PLANNING & ZONING COMMISSION
WEDNESDAY, SEPTEMBER 2, 2020
REGULAR MEETING AT 7:00 P.M.

RE: Night Watch Properties, LLC – 489 Old Hartford Road
Resubdivision (2020-009), Special Permit / Site Plan (2020-010)

Re: True flow Mini-storage and Resubdivision plan prepared for Night Watch Properties LLC,
489 Old Hartford Road, Colchester, Connecticut, prepared by Tarbell Heintz & Assoc., Inc., dated
4/28/19, latest revision 7/18/20

Re: Subdivision plan prepared for Chestnut Hill Development, LLC, 220 Chestnut Hill Road – Colchester, Connecticut, by Dutch & Associates, dated March 9, 2020, latest revision 7/30/20.

RESUBDIVISION PLAN
PREPARED FOR
NIGHT WATCH PROPERTIES LLC
489 OLD HARTFORD ROAD
COLCHESTER, CONNECTICUT

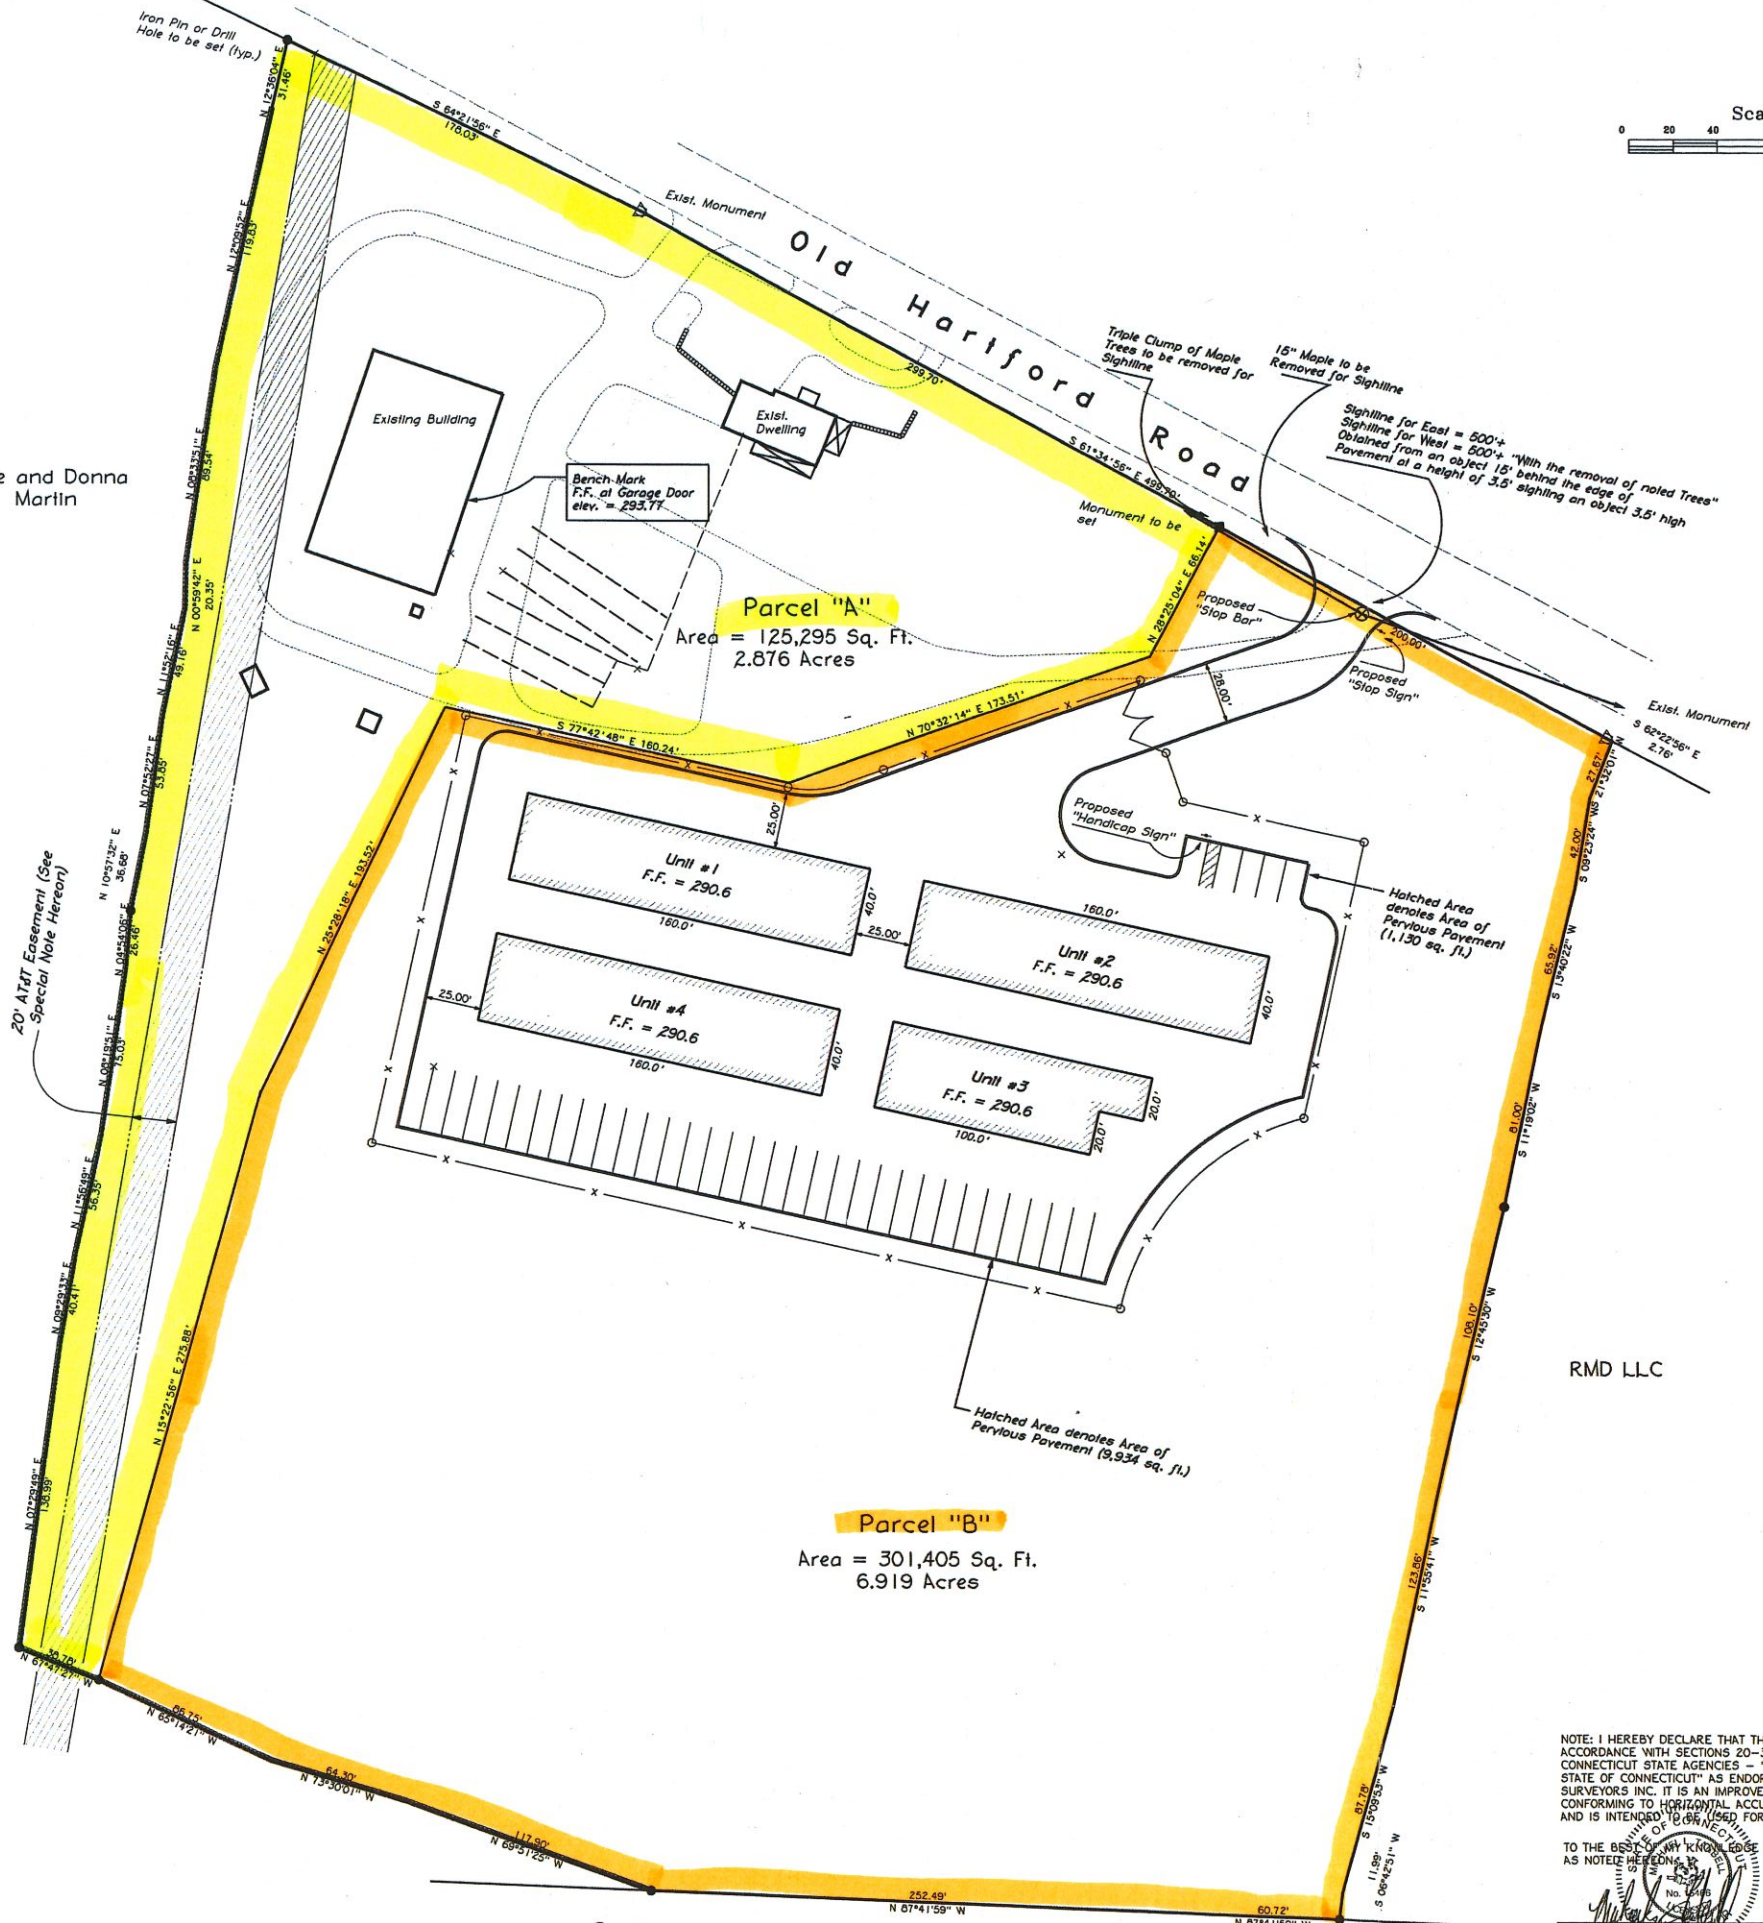
You will note that there is a discrepancy between the number depicted on the plans and the number provided on the Parking Compliance Table on the Resubdivision Plan attached. The applicant has been made aware and will address this with the Commission at the meeting.

SITE PLAN
PREPARED FOR
NIGHT WATCH PROPERTIES LLC
489 OLD HARTFORD ROAD
COLCHESTER, CONNECTICUT

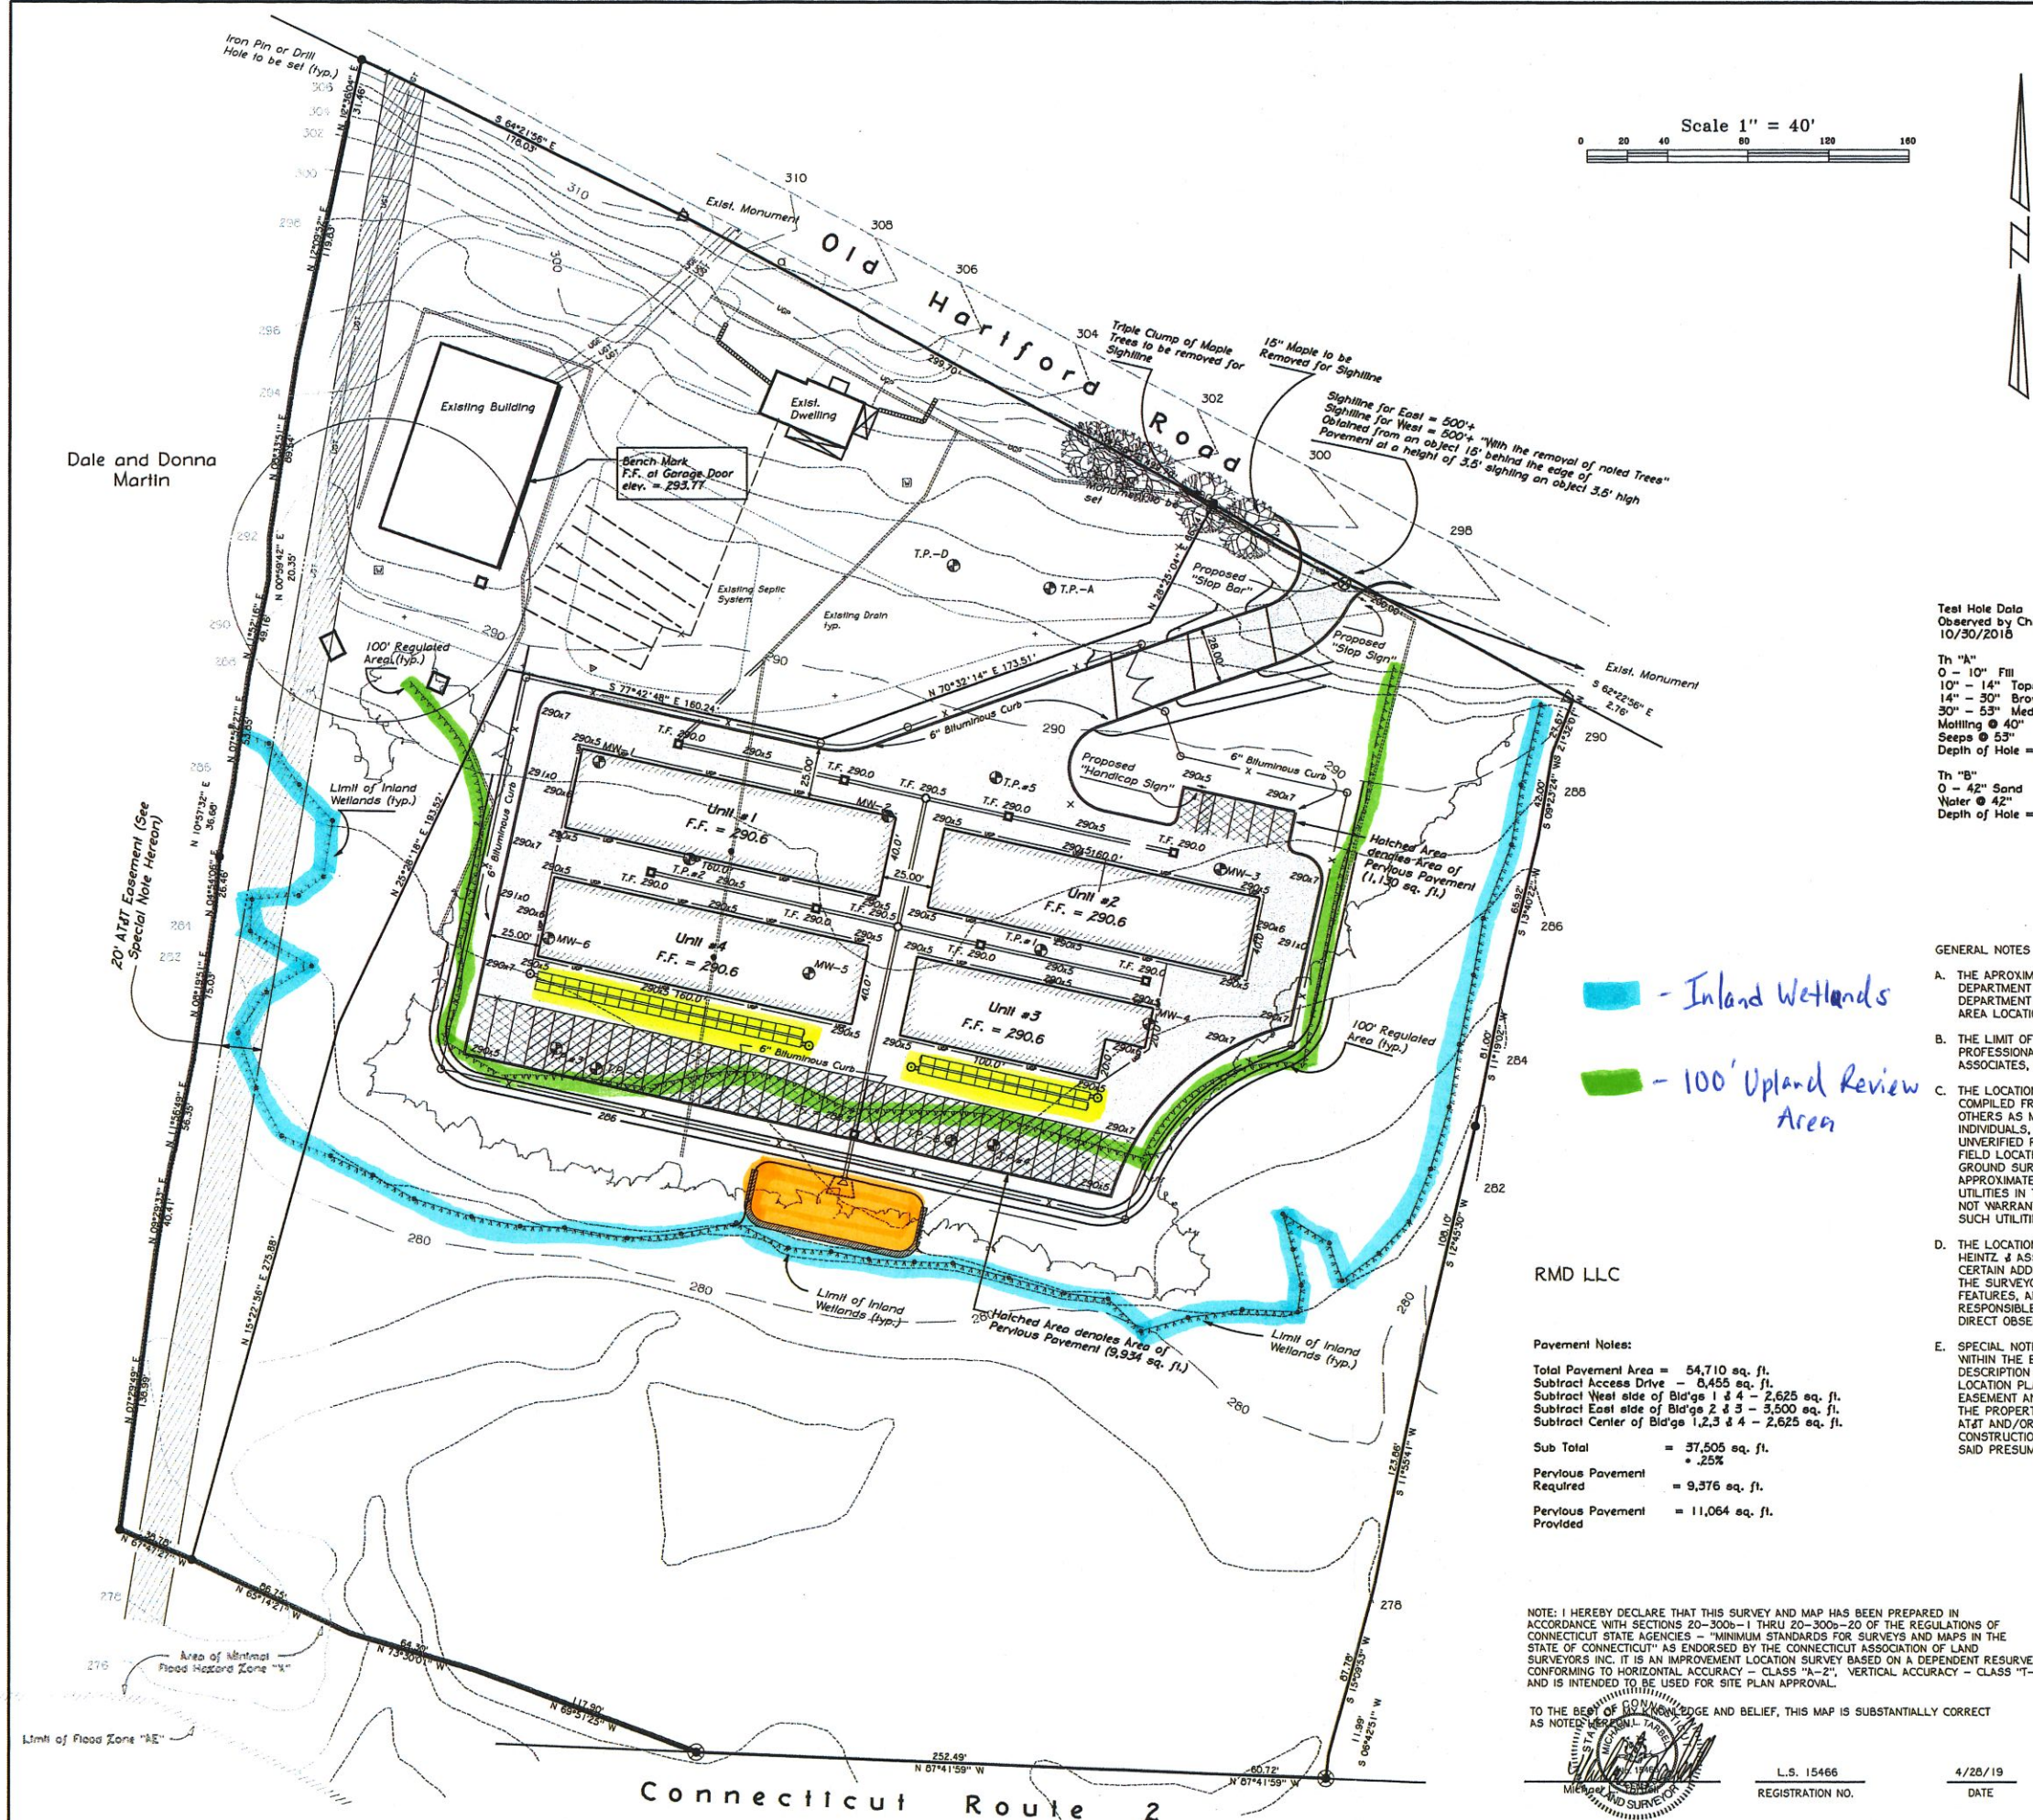
Five (5) parking spaces are proposed in the northeast corner of the paved area. To satisfy the provisions of Section 10.5.3 of the Regulations, approximately 11,064 sq. ft. of pervious parking area will be installed where the five (5) parking spaces are proposed, as well as along the entire southerly extend of the paved area. The pervious parking area is shown with a hatched line-type on the Site Plan attached.

paved driveway and drive aisles around the storage buildings will be collected in catch basins and discharged to a basin (highlighted in orange on the Site Plan) located south of the paved area and just north of the limit of delineated inland wetlands.

Regulated inland wetlands are located along the east and west property boundaries and encompass the majority of southerly half of the site (see Site Plan).

- 1) Need to provide concrete monuments and iron pins at all proposed lot corners in accordance with subdivision regulations section 7.8.
- 2) Show and label toe drain for porous pavement area located at N.E. corner of lot.
- 3) Provide a construction detail for proposed light pole and base.

SUBDIVISION PLAN
 PREPARED FOR
CHESTNUT HILL DEVELOPMENT, LLC
 220 CHESTNUT HILL ROAD - COLCHESTER, CONNECTICUT
 SCALE 1" = 100' - MARCH 9, 2020
 SHEET 2 OF 6

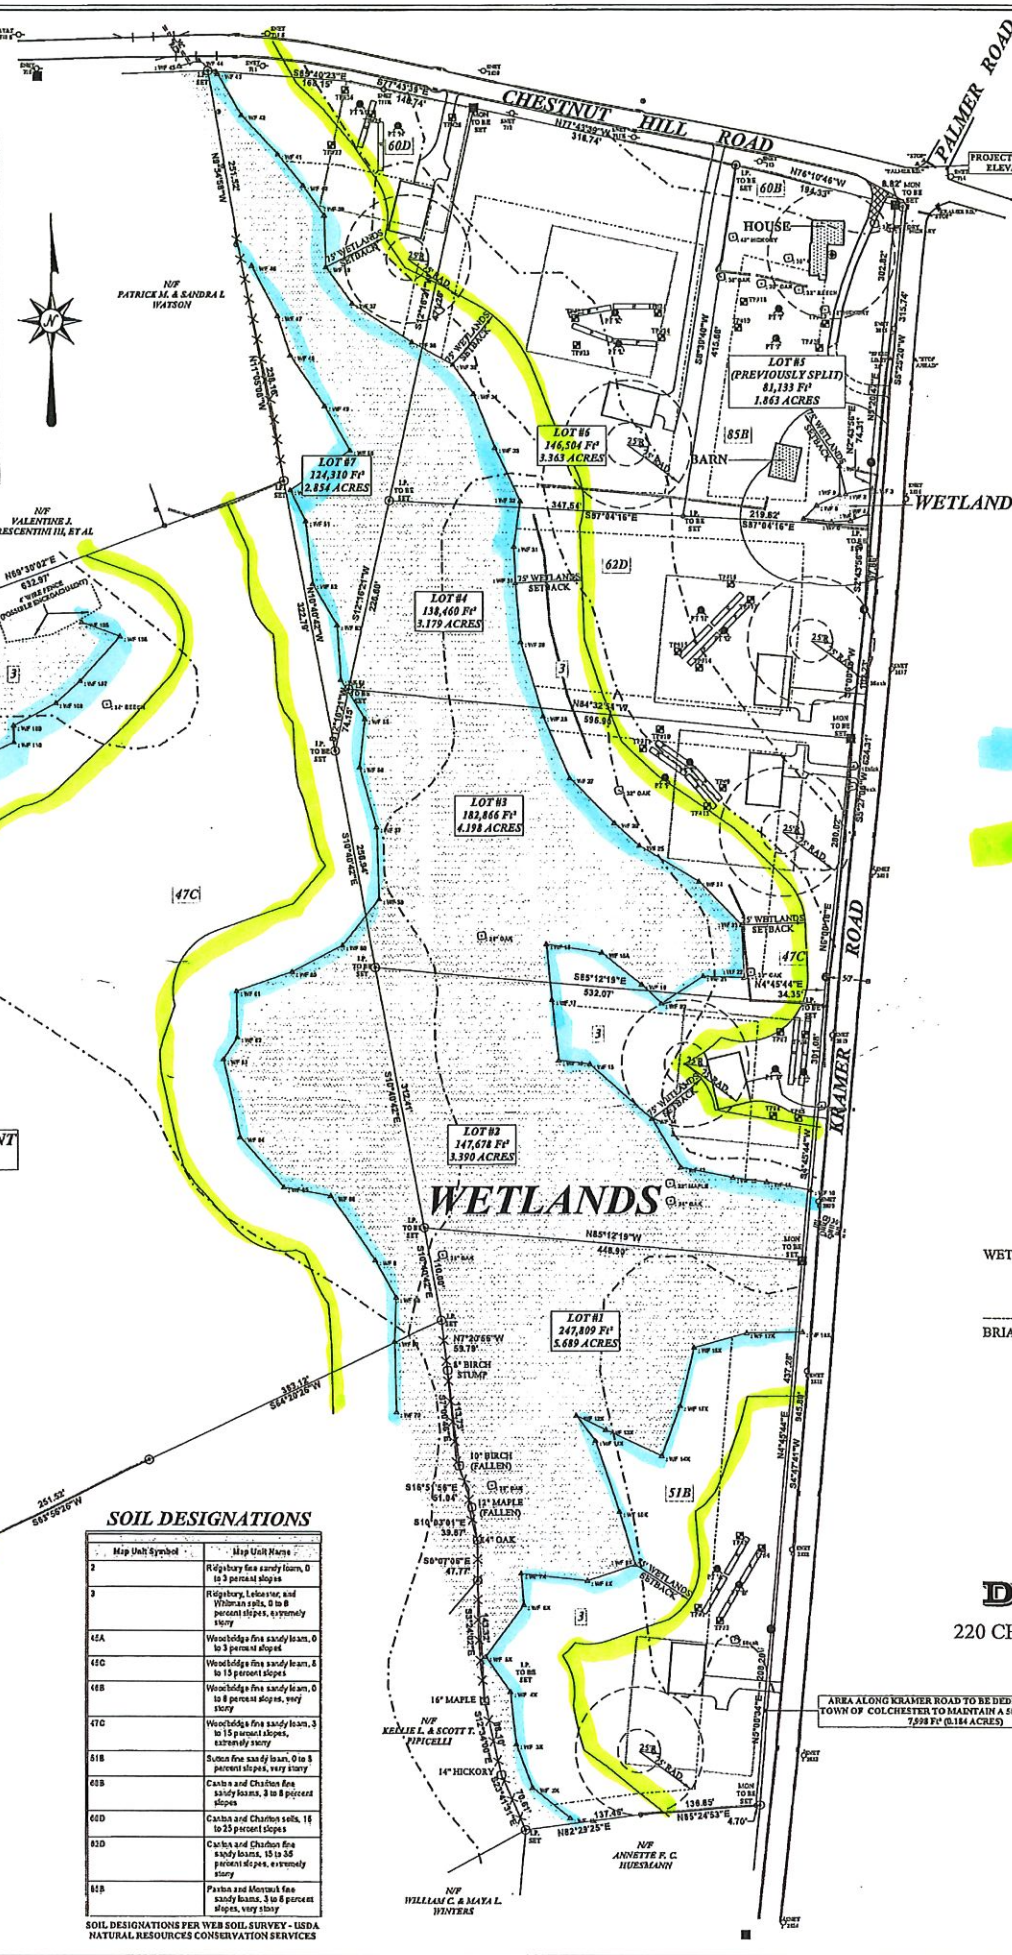
The property consists of approximately 16.6 acres of regulated inland wetlands. The Wetlands Delineation depicted on the Subdivision Plan (highlighted in blue) was provided by Dutch & Associates, Licensed Land Surveyors and Brian Golembiewski, Certified Soil Scientist. The 75' regulated Upland Review Area is highlighted in green.

- 1) Need to provide access to open space from a public road. Also, plans should indicate if the proposed open space is being deeded to the Town. **Proposed open space has been eliminated. Plans should note that this is a proposed Conservation Subdivision and if a fee in lieu of open space is being requested, it should be noted on plans.**

- 2) The plans do not comply with section 6.3.12.1 of the subdivision regulations relative to sidewalk/pedestrian access.
- 3) Based on field observations 3/16/2020, it appears that due to existing horizontal and vertical road geometry, it may be necessary to cut/regrade a portions of roadside embankment west of proposed driveway for lot 7 to achieve the required 300 feet minimum sightline along Chestnut Hill Road. **Need to show accurate existing/proposed grading and provide sightline profile. If profile view shows actual field topography elevations along the proposed sightline, then need to indicate such on the plan and indicate the date of this actual sightline field topography.**

- 4) It is recommended that the proposed driveway for lot 5 be located at a suitable location on Kramer Road to minimize conflict points close to existing road intersection. Also, Kramer road provides the zoning compliant “frontage” for this corner lot. **Plans should indicate that existing driveway within town road right of way for Chestnut Hill Road should be removed and restored with loam, seed and mulch to establish a stable vegetative road shoulder area as approved on previous lot split referenced on plans.**

- 5) Plan sheet 3 shows first 30 feet of driveway to lot 2 at approximately 5% grade. Need to revise proposed grading to be 3% or less.
- 6) The bottom and top elevations for proposed rain garden on lot 6 appear to be erroneous.
